Illustrated Parts List - IPL Update

372 XP

503 63 76-03/04

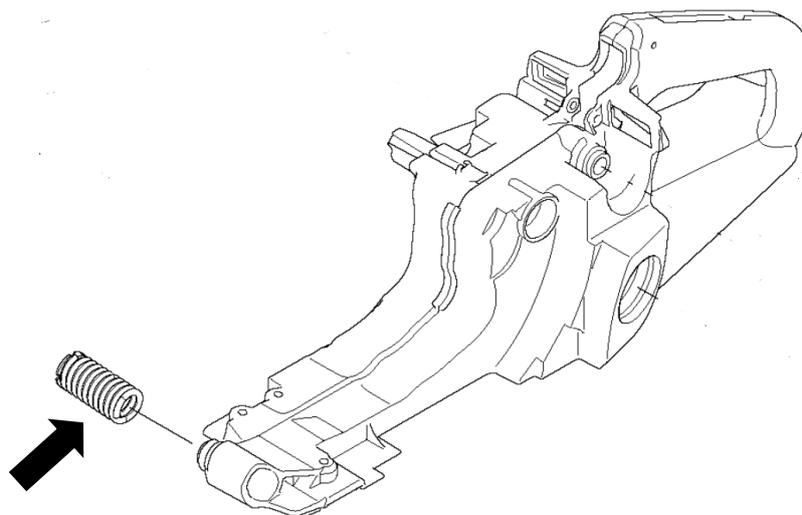
New Antivibration element with ground top on the metal spring. The plastic plug is changed. This gives longer thread length and therefor better fastening of spring in plastic plug.

Reason: Improved durability of antivibration element.

New articles Antivibration element 503 63 76-03 and 503 63 76-04(hard)
